TO: Planholders for Construction of Road 108 Street **Improvement Project**

SUBJECT: ADDENDUM NUMBER 1

TULARE COUNTY RESOURCE MANAGEMENT AGENCY ROAD 108 STREET IMPROVEMENTS PROJECT

ADDENDUM NO. 1

SURVEY MONUMENT NOTES:

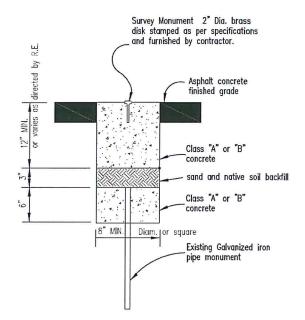
Add following detail to plans:

- All monuments and references shall be permanently stamped pursuant to Bus. and Prof. code sec. 8772.
- Street monument for Gov't. corners and tract boundary corners shall be capped galvanized iron pipe 2" in diameter x 24" in length minimum pursuant to Gov't. code sec. 27580 and Tulare County Ord. code sec. 7074.
- Other street monuments including centerline intersections and beginning and end of curves shall be 1/2" in diameter x 18" in lenfth minimum pursuant to Tulare County Ord. code sec. 7074.
- 4. All existing survey monuments in the construction area shall have corner record or record of survey filed with the county surveyed prior to actual construction and conform to contract specification. Any disturbed or obliterated survey monuments must conform to survey monument details & contract specification.
